# Sundry Print Report

<b>Well Name:</b> NORTH BRUSHY DRAW FED 35	<b>Well Location:</b> T25S / R29E / SEC 35 / NENE / 32.0926247 / -103.9486084	<b>County or Parish/State:</b> EDDY / NM
<b>Well Number:</b> 2H	<b>Type of Well:</b> OIL WELL	<b>Allottee or Tribe Name:</b>
<b>Lease Number:</b> NMNM54290	<b>Unit or CA Name:</b>	<b>Unit or CA Number:</b>
<b>US Well Number:</b> 3001540006	<b>Operator:</b> WPX ENERGY PERMIAN LLC

**Type of Action:** Plug and Abandonment

8. Well Name and No. **Brushy Draw North Federal 35 2H**

WELLBORE DIAGRAM - CURRENT

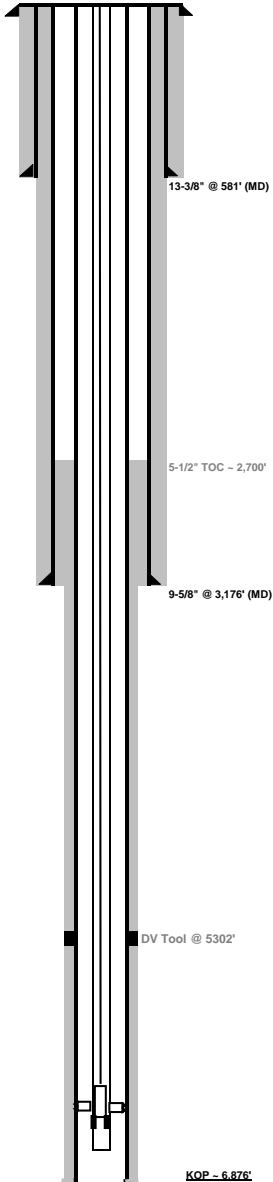
**SPOT PLUG FROM 7350-7177' TO COVER BONE SPRING TOP. NO TAG NEEDED**

**PLEASE BRING THIS PLUG TO 450' TO ADJUST FOR GEOPROG UNCERTAINTY**

**BS TOP: SPOT CL C 7350-7177'**
